**TO:** Mayor John Bradberry, City of Johns Creek  
**ATTN TO:** Ruchi Agarwal, Planner III, City of Johns Creek  
**FROM:** Mike Alexander, Director, ARC Center for Livable Communities  
**RE:** Development of Regional Impact (DRI) Review

**Name of Proposal:** Emory Johns Creek Hospital Expansion DRI 3542

**Description:** A DRI Review of a proposal to revise and expand the existing Emory Johns Creek Hospital facility on its current 65 acre site at 6325 Hospital Parkway off of McGinnis Ferry Road in the City of Johns Creek. The proposed development will consist of the development of 930,299 SF of hospital space and 700,000 SF of medical office space. Two new medical office buildings and a new parking decks along with surface parking will be built on the roughly one-third of the site that is currently forested; the remainder of the project will be built within the existing facility footprint.

GSWCC CERT. (LEVEL II)	
DRAWN BY	TNF
DESIGNED BY	LDC
REVIEWED BY	KHA
DATE	05/03/2022
PROJECT NO.	014384001
TITLE	
<h1 style="text-align: center;">DRI SITE PLAN</h1>	
SHEET NUMBER	
<h1 style="text-align: center;">EX. A</h1>

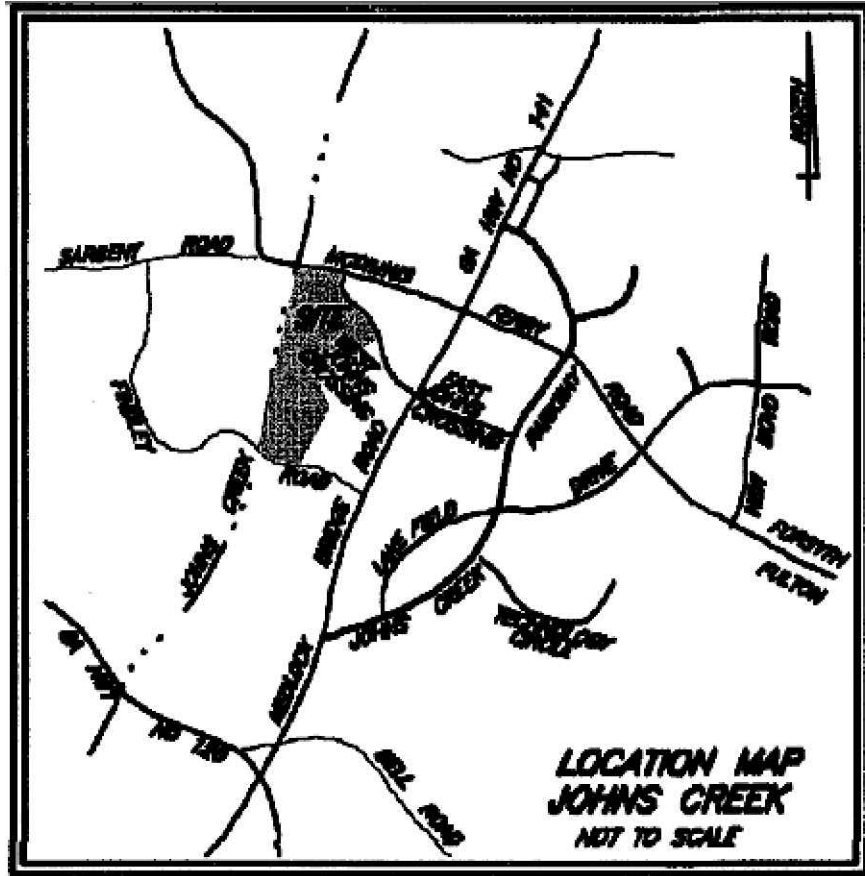
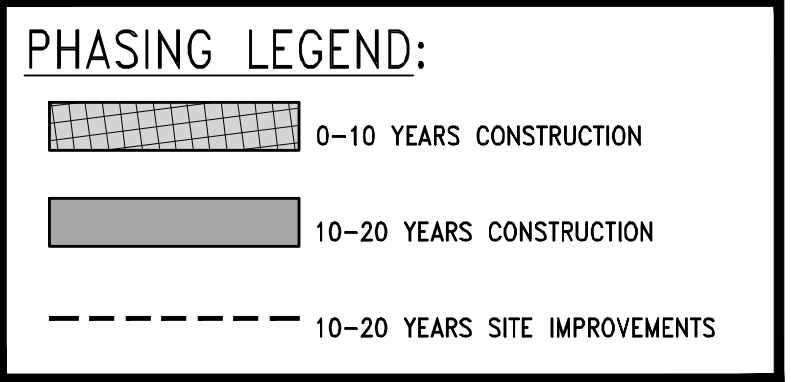
*The current plan offers limited pedestrian mobility within the site and misses the opportunity to create a robust internal pedestrian and bike system that could connect to external systems and provide a functional connection between the two campus areas that also serves a health and exercise purpose. Plan revisions to improve pedestrian mobility would increase the project's alignment with regional pedestrian mobility goals.*

*The project lacks any kind of proposed greenspace or natural areas and will remove a large existing wooded area; the provision of a modicum of these elements could advance regional environmental goals as well as the project's health and wellness focus.*

*Some stream buffers are not shown and others are not consistent the City of Johns Creek Stream Buffer Ordinance, which requires a 50-foot undisturbed buffer and 75-foot impervious surface setback; correct stream buffers should be shown and any proposed intrusions – which may require a variance – labeled.*

*No EV charging stations, or bike parking spaces appear to be proposed; provision of both would advance regional transportation and EV infrastructure priorities.*

The sidewalk connections between the two hospital campus areas are not clear. The provision of a robust internal sidewalk system, possibly incorporating a multi-use trail spur in some location, would be

Approximately 3,261 parking spaces are proposed, many of which will be in new surface parking lots. Ideally this number could be reduced through parking demand management or moving some of the surface spaces to decks to free up some area for other amenities or uses.

It is unclear from the plans if any EV charging spaces, or bike parking spaces are proposed. The provision of both would be supportive of regional multi-modal transportation and environmental goals. Care should be taken to ensure that the development, as constructed, promotes an interconnected, functional, clearly marked and comfortable pedestrian experience on all streets, paths, entrances, and parking areas. To the maximum extent possible, new driveways and intersection corners where pedestrians will cross should be constructed with minimal curb radii to reduce speeds of turning vehicles and decrease crossing distances for pedestrians.

The USGS coverage for the project area and the project site plan both show Johns Creek forming the western boundary of the project property. The site plan shows a 35-foot buffer measured from top of bank of the Johns Creek. The 25-foot State Erosion and Sedimentation Buffer is not shown. In addition, the 35-foot buffer is not consistent with the City of Johns Creek Stream Buffer Ordinance, which requires a 50-foot undisturbed buffer and 75-foot impervious surface setback along the stream. The correct City buffers, as well as the State 25-foot Erosion and Sedimentation buffer need to be shown along Johns Creek. Any intrusions into these buffers may require a variance. Any unmapped streams on the property will be subject to the Johns Creek Stream Buffer Ordinance. Any unmapped waters of the State are subject to the requirements of the State 25-foot Erosion and Sedimentation buffer.

The USGS coverage for the project area and the project site plan both show Johns Creek forming the western boundary of the project property. The site plan shows a 35-foot buffer measured from top of bank of the Johns Creek. The 25-foot State Erosion and Sedimentation Buffer is not shown. In addition, the 35-foot buffer is not consistent with the City of Johns Creek Stream Buffer Ordinance, which requires a 50-foot undisturbed buffer and 75-foot impervious surface setback along the stream. The correct City buffers, as well as the State 25-foot Erosion and Sedimentation buffer need to be shown along Johns Creek. Any intrusions into these buffers may require a variance. Any unmapped streams on the property will be subject to the Johns Creek Stream Buffer Ordinance. Any unmapped waters of the State are subject to the requirements of the State 25-foot Erosion and Sedimentation buffer.
